AMENDMENT 1

TIBET ROAD
(TRIBUTARY T TO E. 48TH AVE.)
SITE PLAN FOR INFRASTRUCTURE
TITLE: LANDSCAPE PLAN
DATE: February 24, 2023

TIBET ROAD (TRIBUTARY T TO E. 48TH AVE.)
SITE PLAN FOR INFRASTRUCTURE
TITLE: LANDSCAPE DETAILS
DATE: February 24, 2023

TIBET ROAD
(TRIBUTARY TO E. 48TH AVE.)
SITE PLAN FOR INFRASTRUCTURE
TITLE: LANDSCAPE PLAN
DATE: February 24, 2023

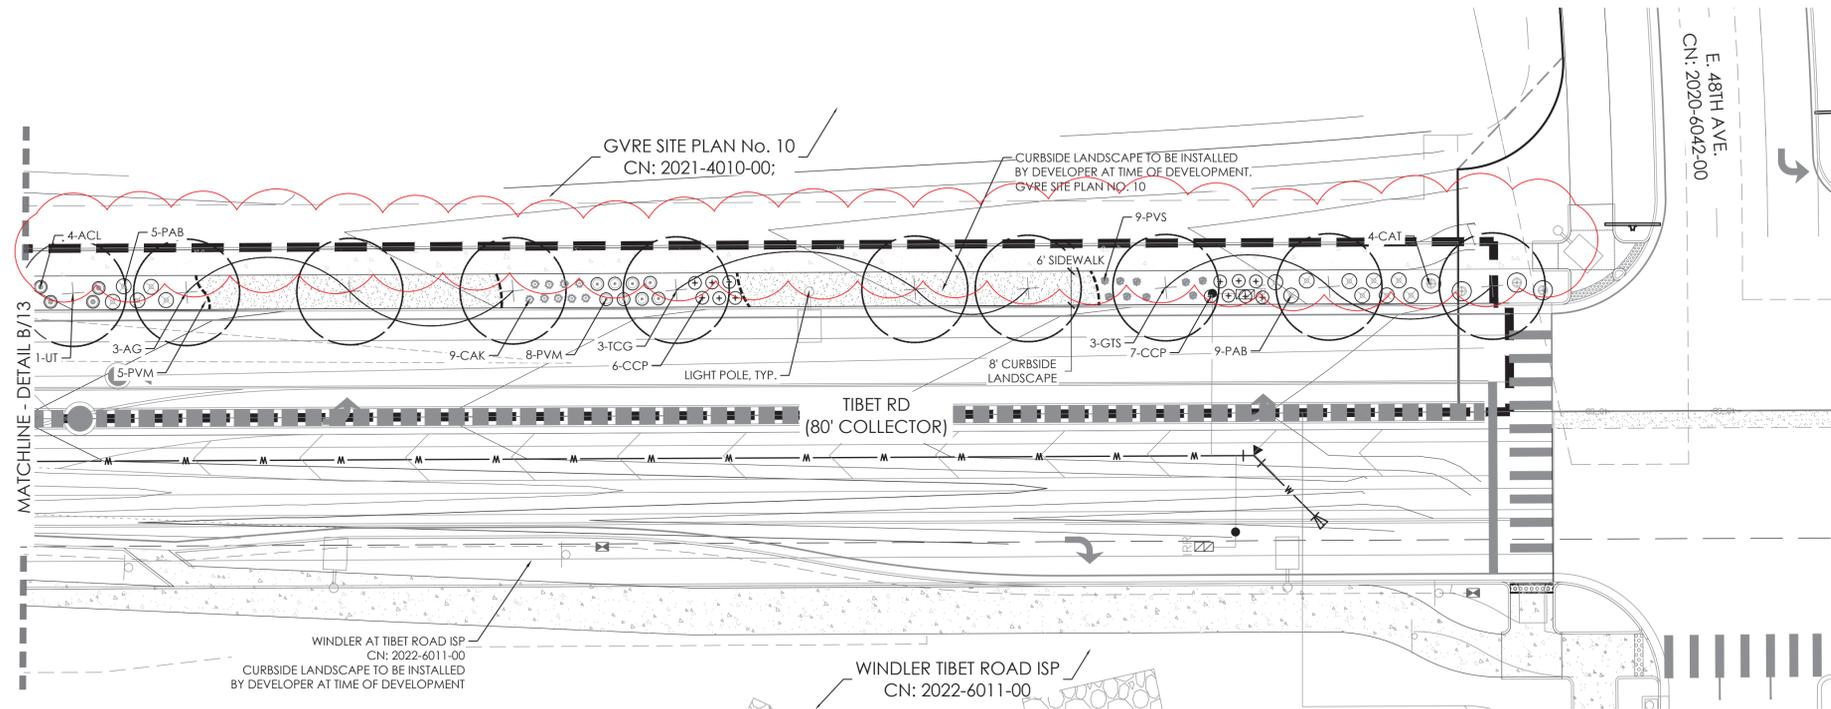
AMENDMENT 1
- REMOVE CRUSHER FINES BIKE PATH

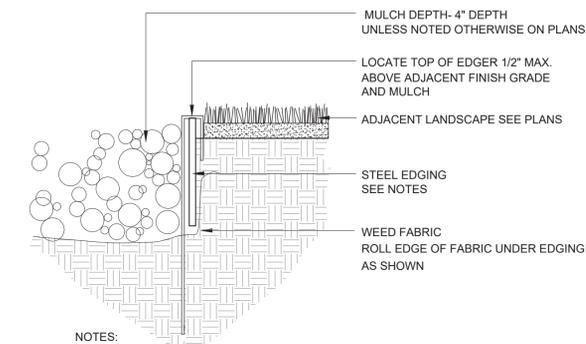
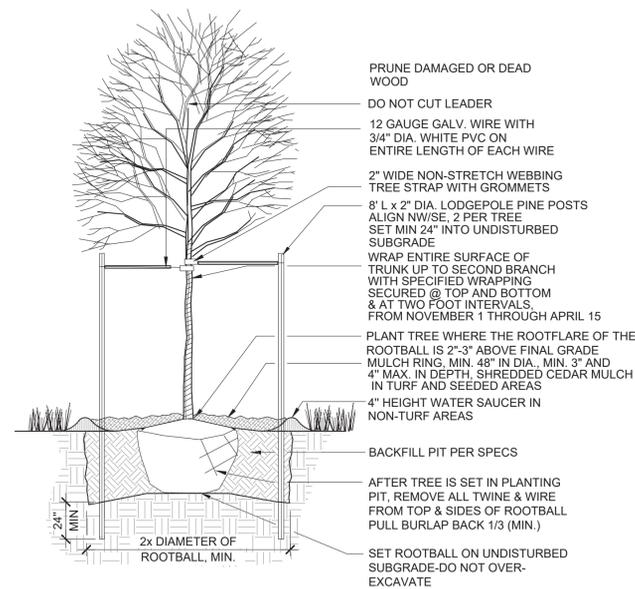
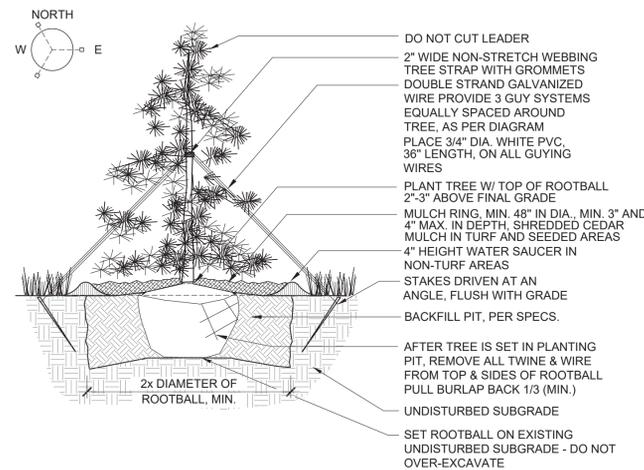
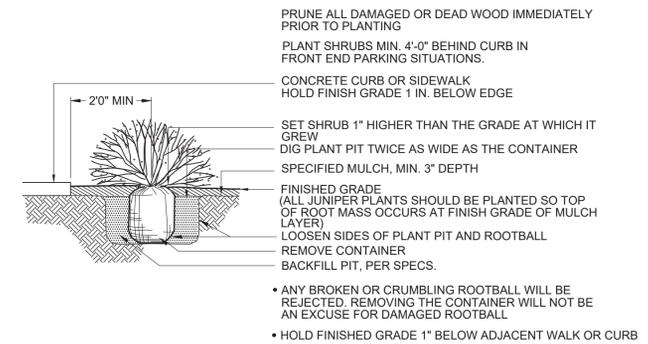
- UPDATED PLANT QUANTITIES
- ADDED EAST SIDE OF TIBET TO CURBSIDE LANDSCAPE REQUIREMENTS
- MOVED DETAILS FROM SHEET 15 TO THIS SHEET
- REVISED CURBSIDE LANDSCAPE REQUIREMENTS

TIBET ROAD
(TRIBUTARY T TO E. 48TH AVE.)
SITE PLAN FOR INFRASTRUCTURE
TITLE: LANDSCAPE DETAILS
DATE: February 24, 2023

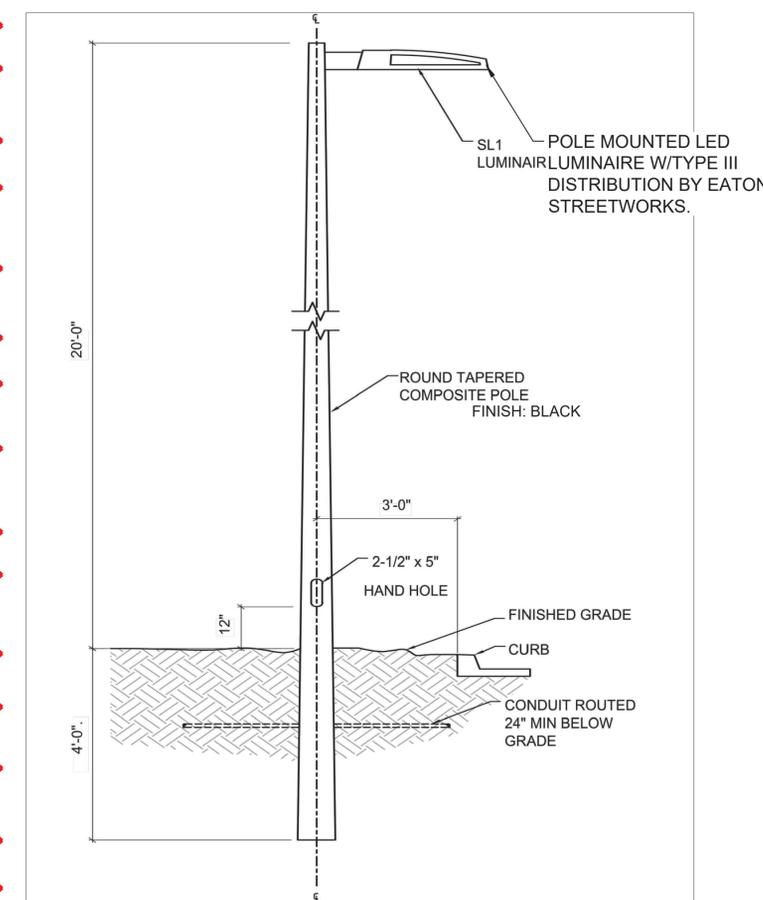
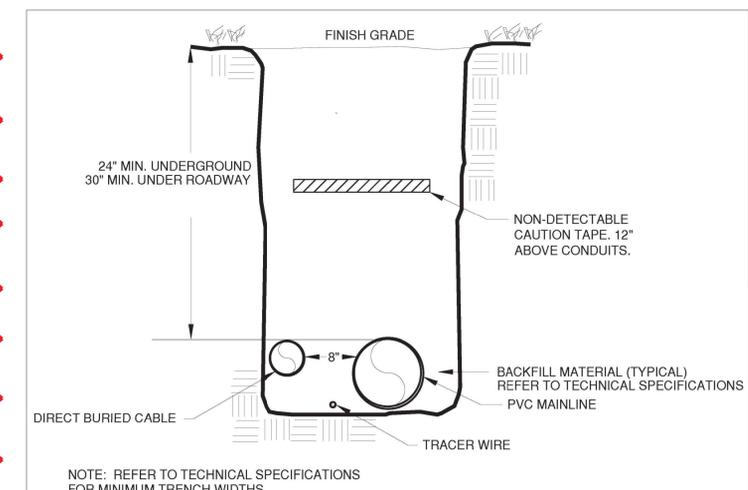
1
AMENDMENT 1
- REMOVE CRUSHER FINES BIKE PATH
- MOVED DETAILS TO SHEET 14
- ADDED STREET LIGHT DETAILS
